**Response to Comments on the
Draft Initial Study**

1440 Center

City of Scotts Valley, CA

Responses to Comments on Draft Initial Study

Figure #1; SVWD & SLVWD Groundwater Levels - Production

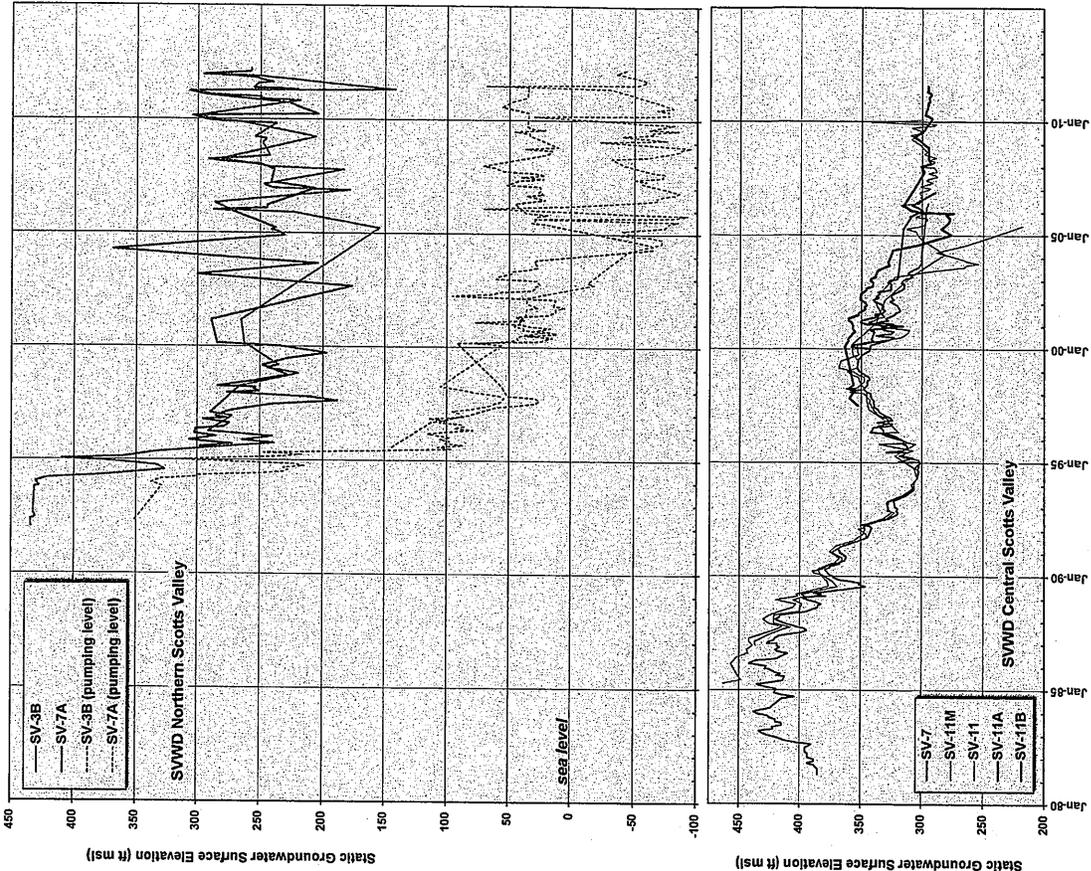
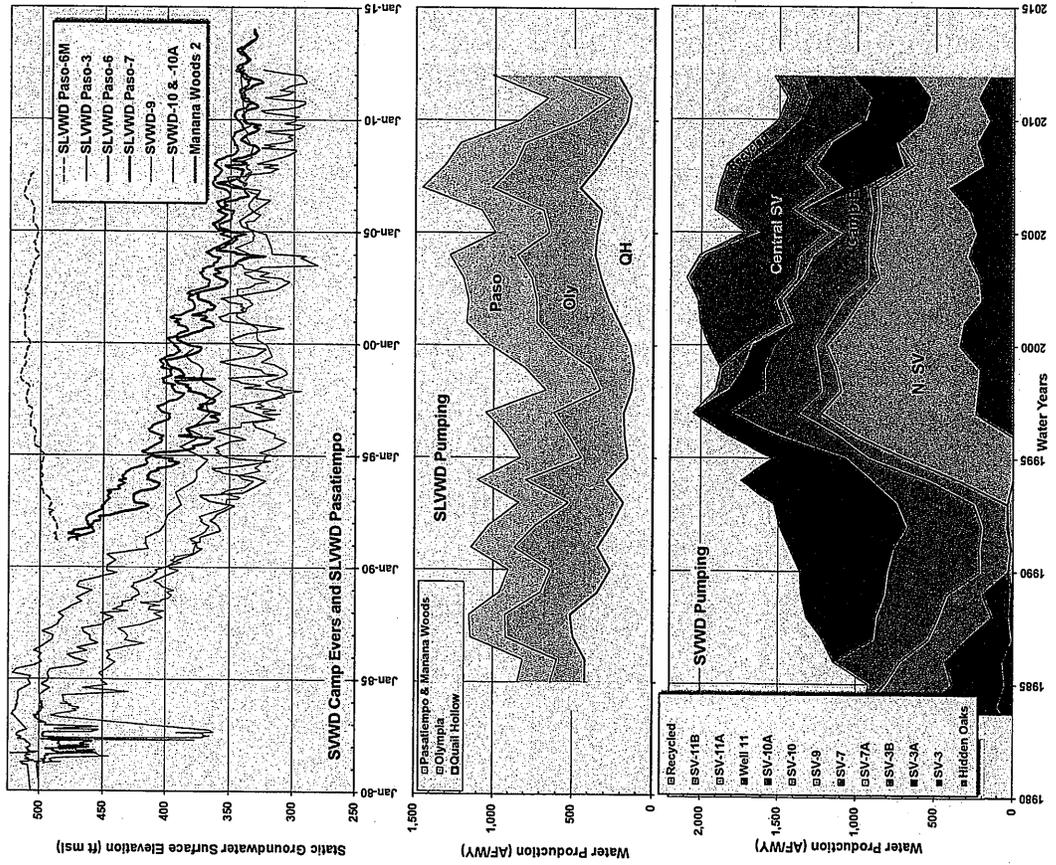
Comment #6: The proposed project's water use must be considered as a cumulative impact in the context of existing groundwater production in the Scotts Valley area. As shown in the attached figure, static groundwater levels in the Santa Margarita and Lompico sandstone aquifers have declined up to 300 feet since 1980. Current conditions appear to be unsustainable and/or having significant long-term impact on regional stream baseflows. Although water use declined during the recession, and the use of recycled water has increased, groundwater levels remain significantly drawn down, with some pumping levels below sea level. Furthermore, although the proposed project replaces a roughly similar use at the same site that ended in 2011, each new or renewed service should be evaluated in the context of a sustainable groundwater management plan. Additional analysis is needed to define the region's sustainable groundwater yield and acceptable impact to the local hydrology.

As also clarified in the revisions to the Initial Study, the SVWD is currently obligated to allocate 20,274 gpd to the site based on historic use and existing connections. Therefore, the increased demand in water supply by the project is 3,651 gpd, which represents 0.3% of the SVWD's existing service area water use. This revised analysis supports the Initial Study conclusion of the proposed project having a less-than-significant impact. Revisions have been made to the analysis in the Initial Study reflecting these clarifications. The revisions are provided as clarification to the Initial Study and do not represent a new and/or previously unidentified impact.
